Mega65Modular MPPT v0.1  
garners  
License: CERN-OHL-S v2  
Year: 2025

**Title: Mega65Modular MPPT**

Rev: v0.1  
Id: 1/1

Sheet: /  
File: mppt-charge.kicad\_sch

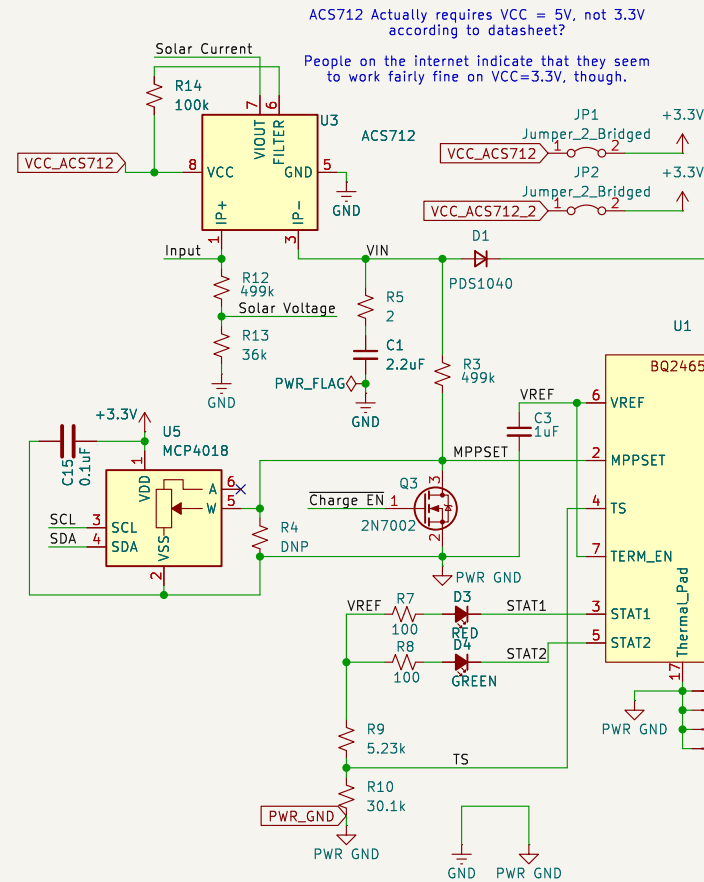
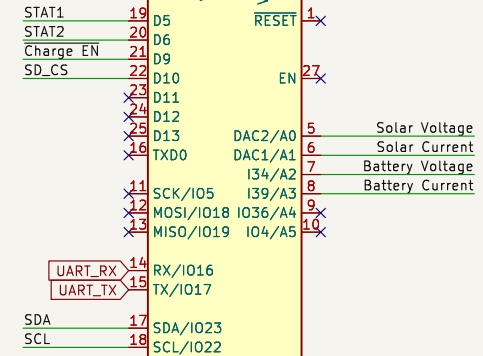
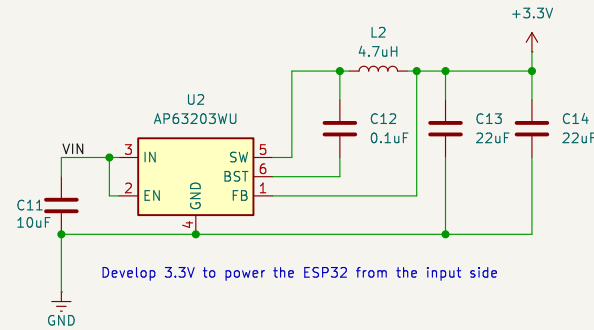
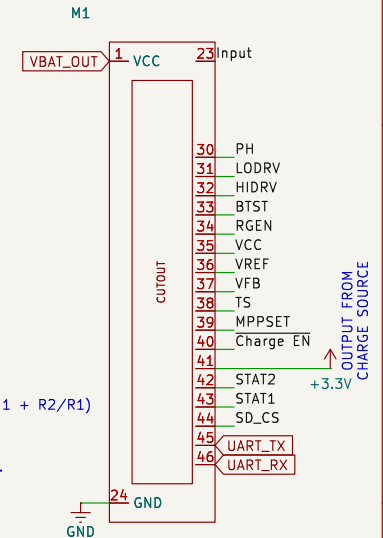
ACS712 Actually requires VCC = 5V, not 3.3V according to datasheet?
